CITY OF CODY
PLANNING, ZONING, AND ADJUSTMENT BOARD
TUESDAY, JANUARY 22, 2019
CITY HALL COUNCIL CHAMBERS @ 12:00 NOON

MEETING DATE:	JANUARY 22, 2018	TYPE OF ACTION NEEDED	
AGENDA ITEM:		P&Z BOARD APPROVAL:	X
SUBJECT:	SITE PLAN REVIEW: WASTEWATER TREATMENT FACILITY PHASE 2 UPGRADES. SPR 2018-26	RECOMMENDATION TO COUNCIL:	
PREPARED BY:	TODD STOWELL, CITY PLANNER	DISCUSSION ONLY:

MEETING DATE:	JANUARY 22, 2019	TYPE OF ACTION NEEDED	
AGENDA ITEM:		P&Z BOARD APPROVAL:	X
SUBJECT:	SITE PLAN REVIEW: HAMPTON INN AND SUITES. SPR 2018-24	RECOMMENDATION TO COUNCIL:	
PREPARED BY:	TODD STOWELL, CITY PLANNER	DISCUSSION ONLY:

PROJECT: **WWTF PHASE 2 UPGRADE**
TITLE: **UV BLDG SITE PLAN**

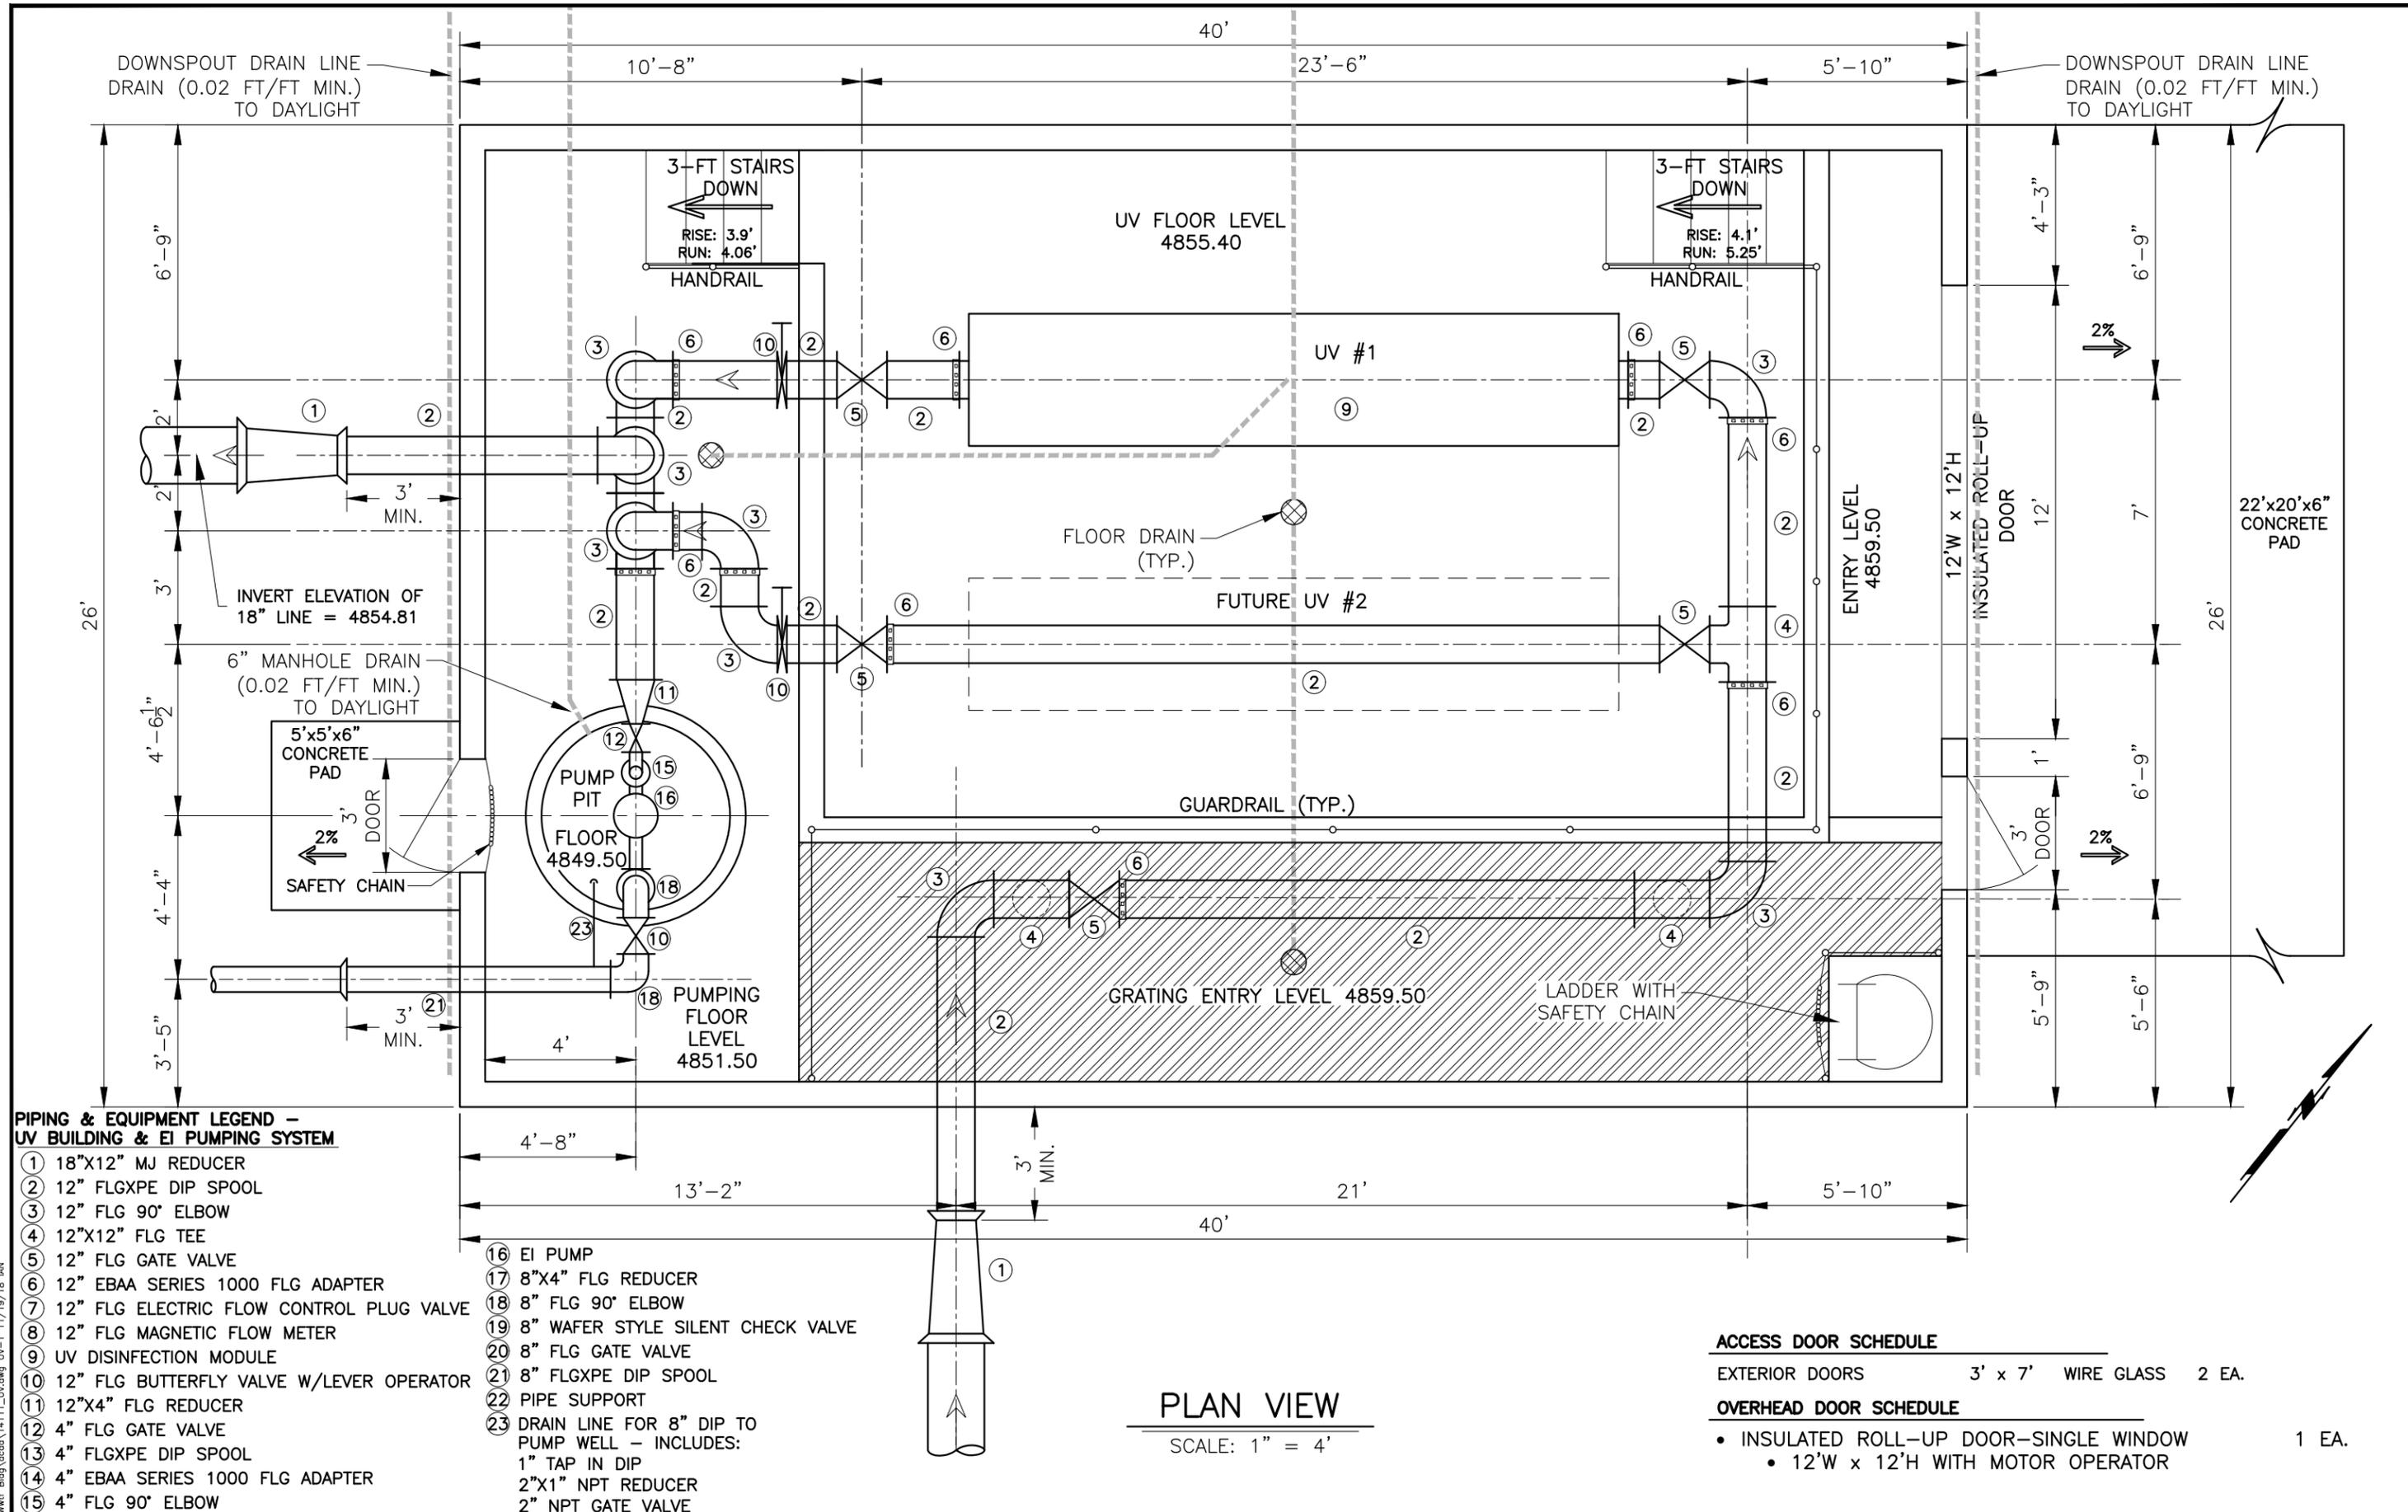
It is noted that the UV building will be constructed on a new elevated pad, which is about 10 feet higher than existing grade—refer to sheet UVB-0.

Planning staff is not yet 100% comfortable that the work associated with the UV building pad will not cause or be affected by slope stability issues (too many bad experiences with landslides). The building pad for the UV building will add approximately 900,000 pounds to the top of a cliff that is likely at or near its angle of repose (maximum slope that it is still stable). Adding significant weight to the top of a hillside is not generally wise. It is requested that the applicants engineer give a description of their engineering analysis and conclusions to the Planning and Zoning Board regarding the stability of the slope and addition of the UV building pad.

SITE PLAN

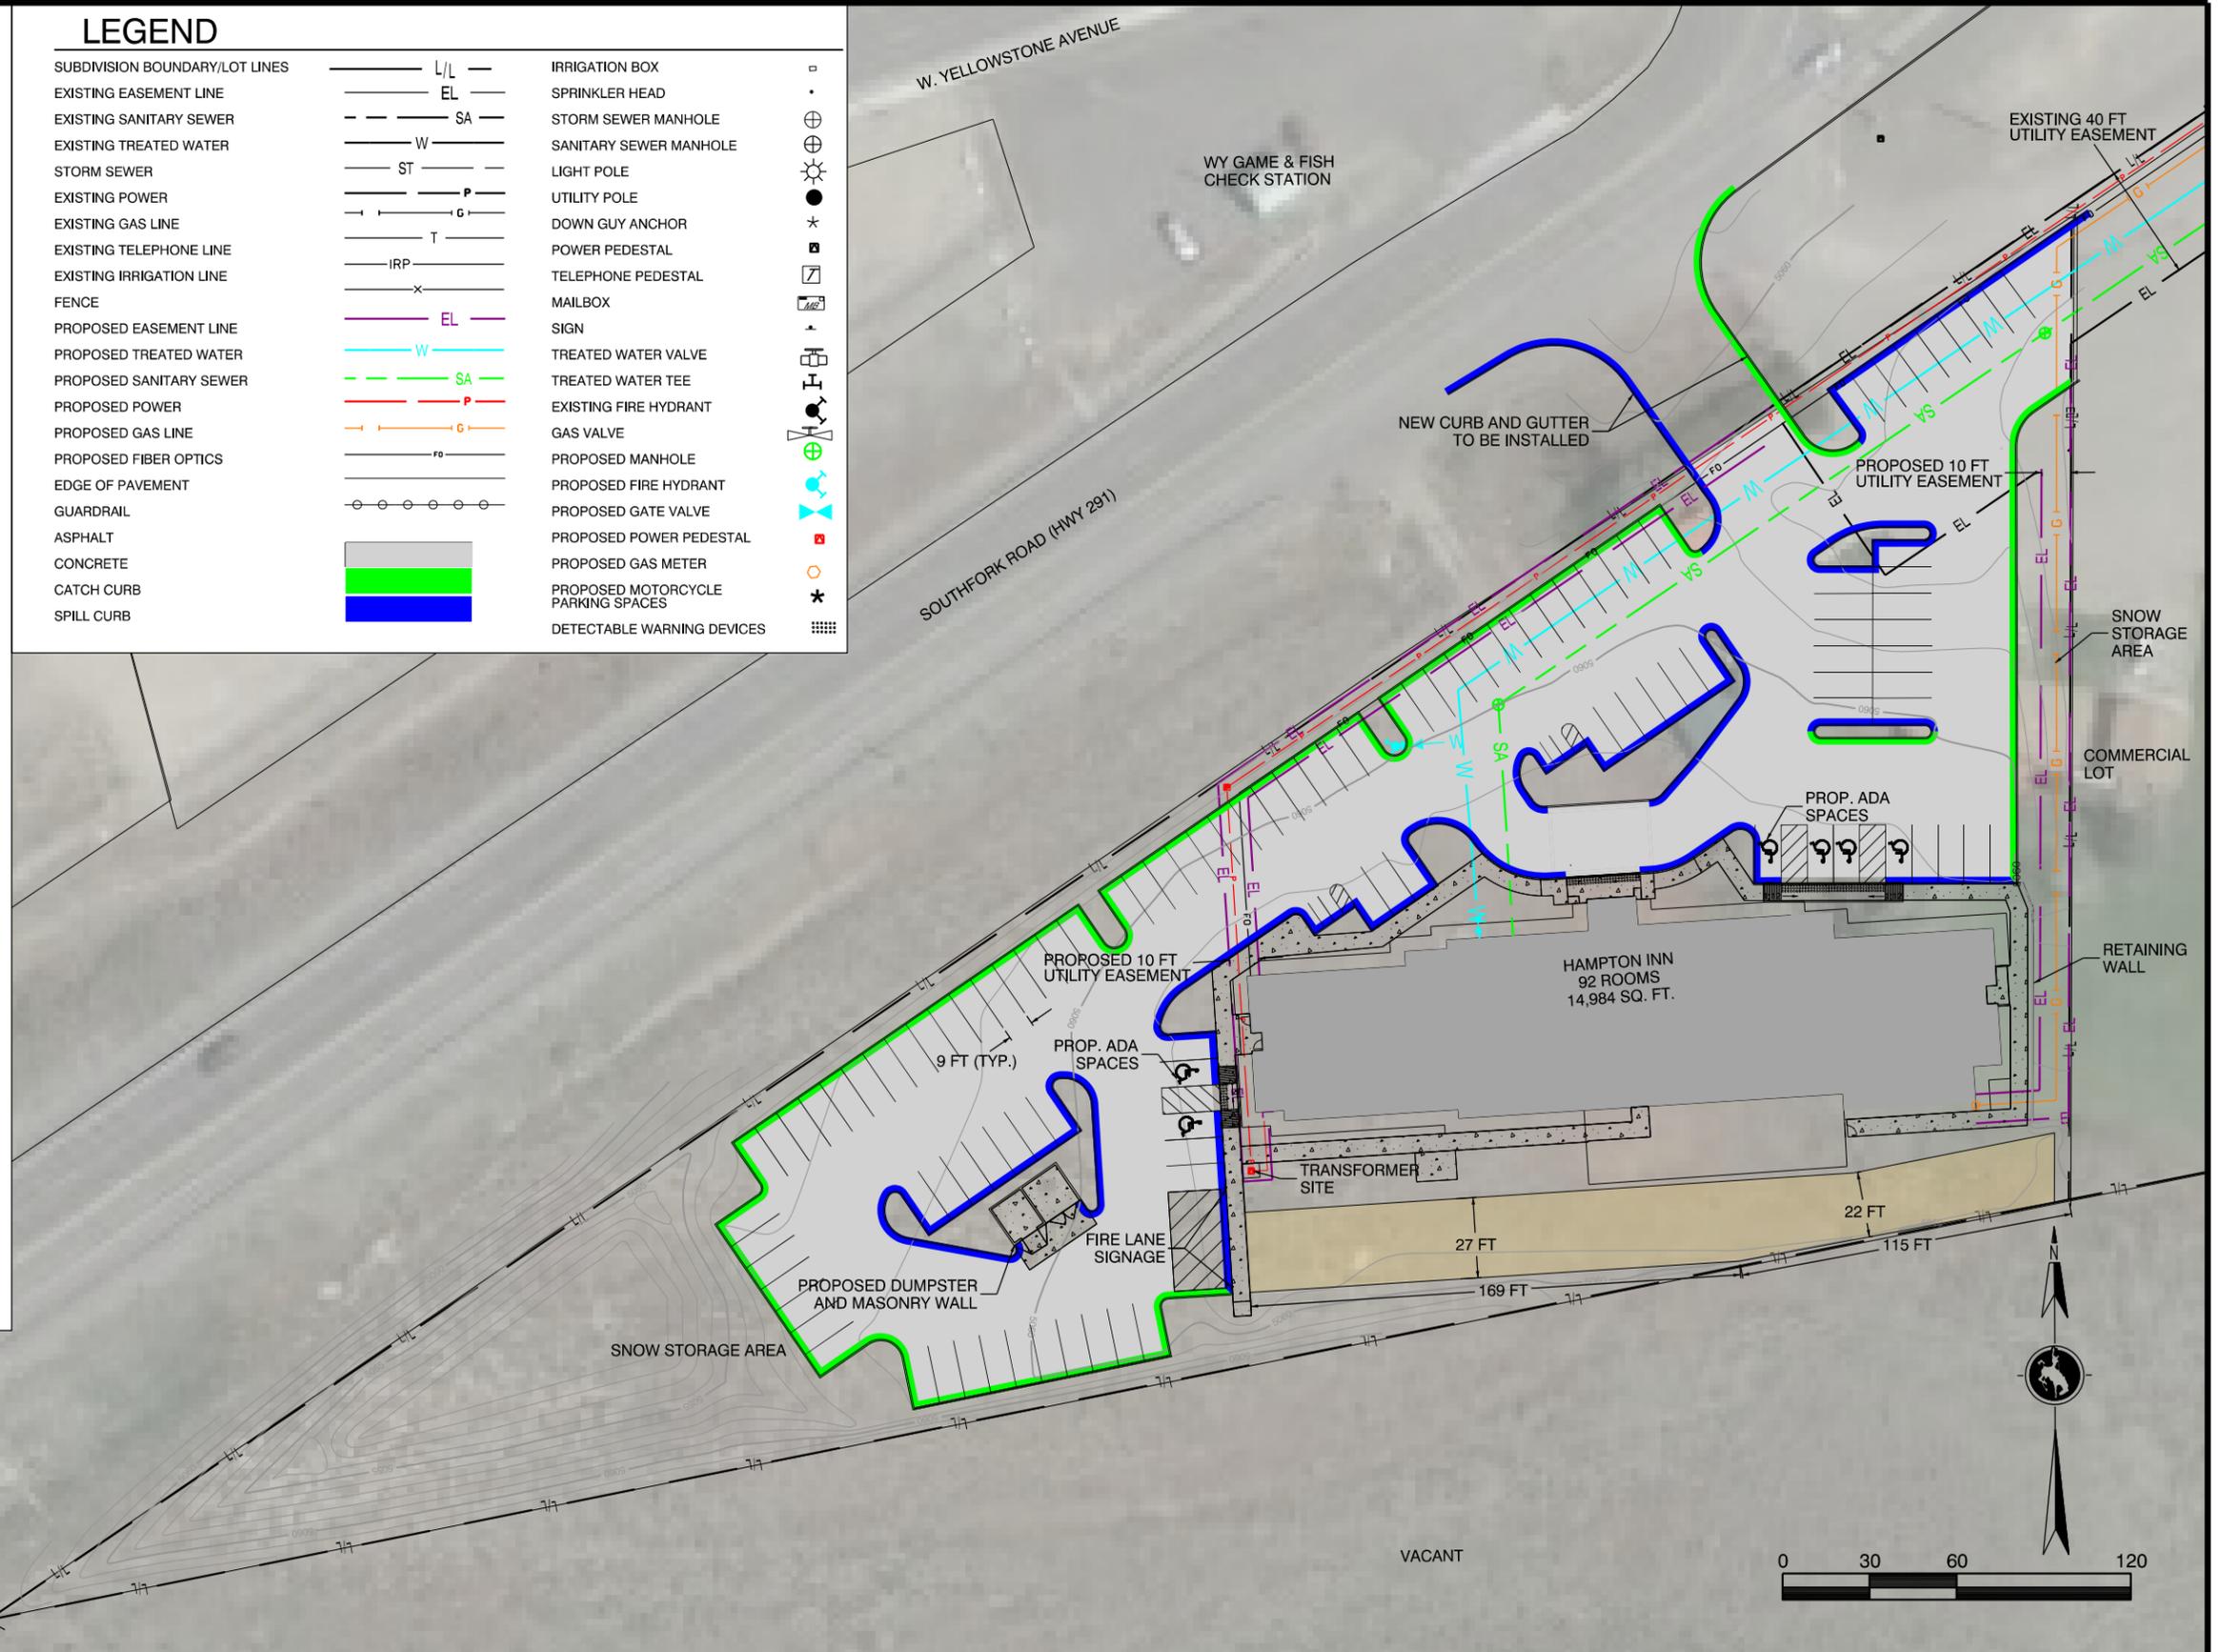
With the approach relocated, the existing approach needs to be closed. At a minimum, the site plan (Page 2 of 7) needs to show the curbing on the northeast side of the approach extending to tie into the existing curbing to the northeast of the approach that is being closed. If material is to be removed from the closed approach, it should be noted on the demolition plan and addressed in the WYDOT encroachment permit(s).

9. Any details or considerations that the Public Works director determines is lacking in the storm water/drainage plan.
10. Add curbing to extend to the northeast, tying into the existing curb. Also add sidewalk from the east property line extended north, along the back of the new curbing and around the radius of the approach into the site (design to be reviewed).
